January 21, 2022

Comments from CSERC/TRT in response to the SERAL DEIS

Figure CSO 4. Distribution of CSO PACs (red) and Territories (black circles) in the SERAL project area (magenta) in relation to private land (gray).

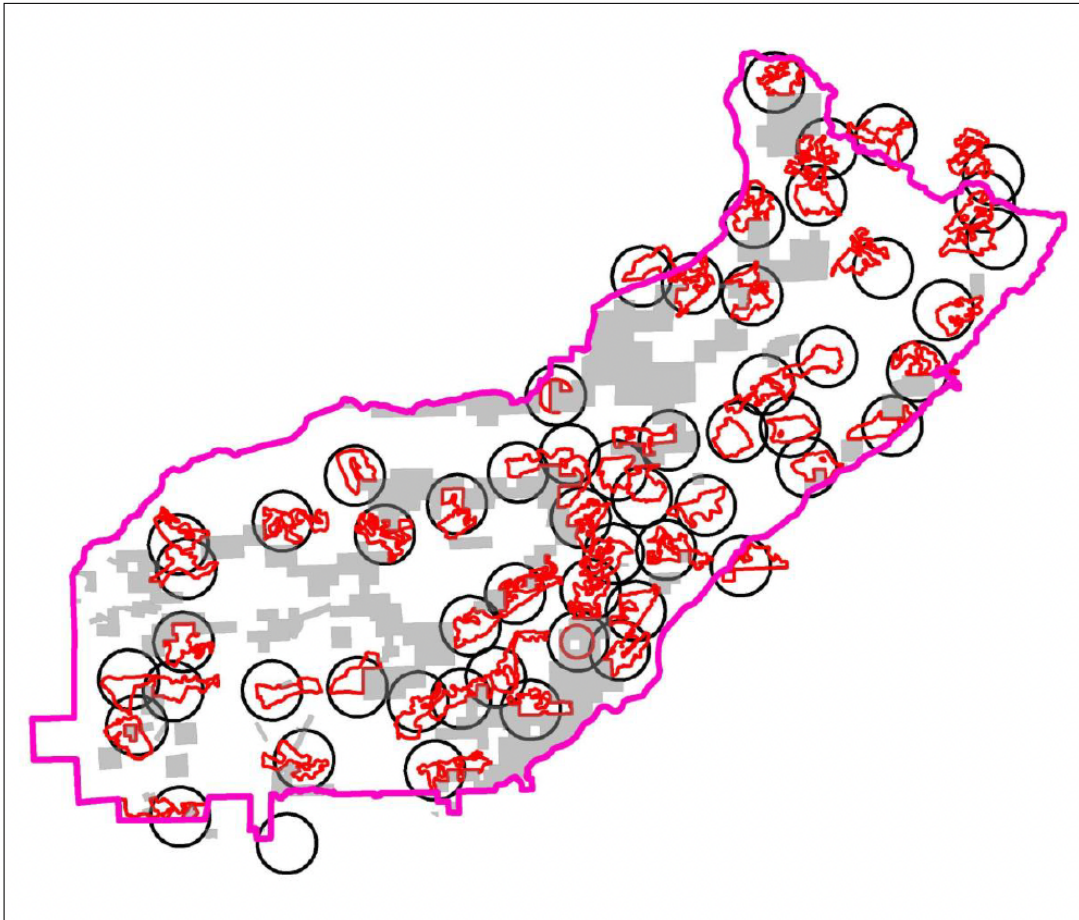
One apparent problem of Circular Territories (as planned by the SERAL project) is that numerous 1,000-acre territories include measurable amounts of private or industrial timberlands within the supposed "protected" 1,000-acre Territory.

This obviously would not result in 1,000-acres of actual protection for the CSO, since the Forest Service has no authority over what management is applied on private lands. Worse, the Forest staff is fully aware that SPI applies clearcut-type "Alternative Prescription" logging methods and other even-age forest management treatments on their private forest lands.

The graphic taken from the SERAL Terrestrial Wildlife BE is one example of information showing how Territories overlap with private lands. As noted above, the Forest Service cannot in any way influence or assure a desired outcome of how private lands are managed. Thus, to provide for the minimum 1,000-acre Territory, private lands should not be counted towards the objective of 1,000 acres of protected habitat within a Territory.

Accordingly, we urge that - for all Territories in the SERAL project area where nest stands are located on national forest lands - the Forest Service should ensure in the FEIS that 1,000 acres of the Territory (be it a circular territory or HRCA) is composed of national forest lands without counting any acres of private lands. Where a circular Territory includes measurable amounts of private lands, we ask that the circle for that Territory be widened sufficiently so that it includes no less than 1,000 acres of national forest land.

**Protected Activity Centers NOT in Territories
SERAL DEIS | LAND-SERAL-WILDLIFE-02**

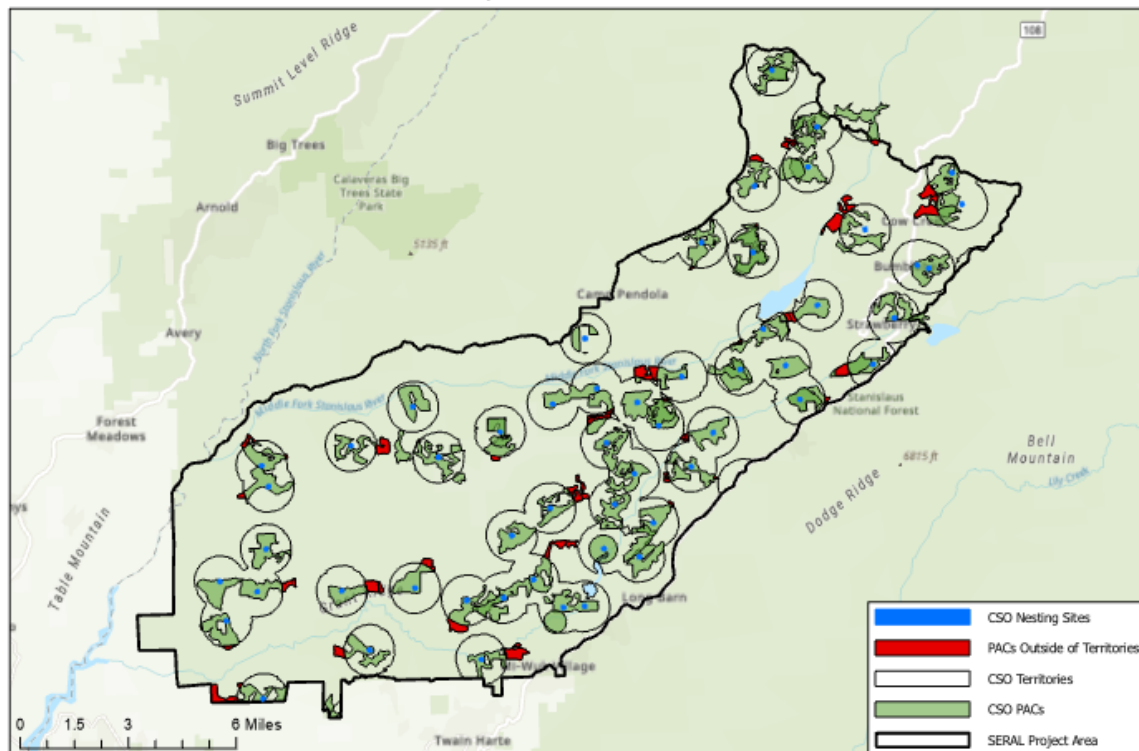
This comment is designed to highlight a **shortcoming** and **modeling error** within the circular Territories designated within the SERAL DEIS. We have identified a potential misapplication of the 2019 CSO Strategy within the SERAL DEIS, and wish to bring it to the attention of the USDA Forest Service. This comment is not designed to critique circular Territories instead of amoeba-shaped Home Range Core Areas (HRCAs). We recognize the value-add that a circular-shaped Territory provides to CSOs as central-place foragers, and that Territories can facilitate management of Landscape Management Units to create High-Quality (5D, 5M, 6 WHR Classification) ecosystems, and accept that the 2019 CSO Strategy is the best available science for ecosystem management in the Sierra Nevada.

We request that Territories be modified to be non-circular when PACs extend beyond the 1,000-acre Territory Footprint, in compliance with the 2019 CSO Strategy and the language in the SERAL DEIS. We request that the 1,621 acres be added on to the 48,485 acres of CSO Territory identified in the ForSys model, resulting in a cumulative 50,106 acres of CSO Territory, encompassing all sub-units of PACs.

***Note that this comment uses the PACs delineated in SERAL_ForSys_Input_v16, which does not represent the total acreage of PACs listed in the SERAL_PACs_DEIS. We request that this modeling be recomputed using ALL 19,306 PAC acres.**
